Equipment Recall

ER22-14

ENTERTAINER BUSINESS - SEAT BRACKET

NHTSA Recall #22E-004

FIGURE 1: KIT 860351 BRACKET POSITION 1 (4 seats)

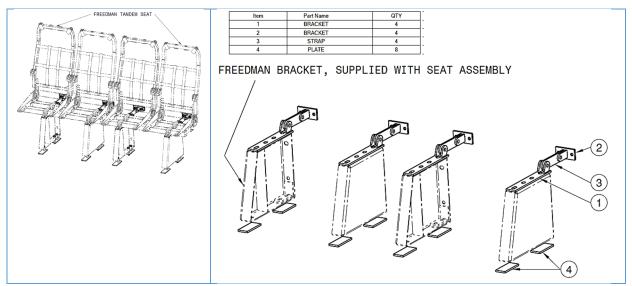
defective seat bracket kits to be replaced		new replacement kits	
kit 860351	seat bracket asm, position 1	kit 868187	seat bracket asm, position 1
kit 860355 3a	seat bracket asm, position	kit 868188	seat bracket asm, position 3a

DEFECTIVE BRACKETS

FIGURE 2: Kit 860355 BRACKETS POSITION 3A (1 or 2 seats)

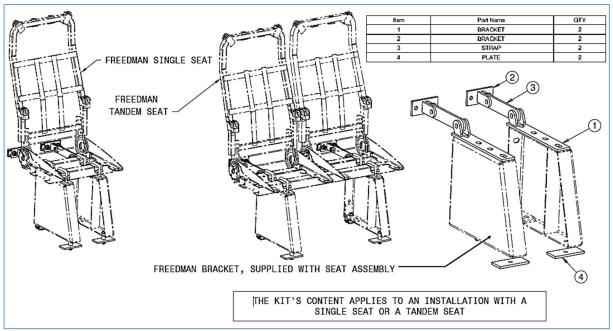
The defective brackets are missing ¼ fillet weld beads as shown on the images below.
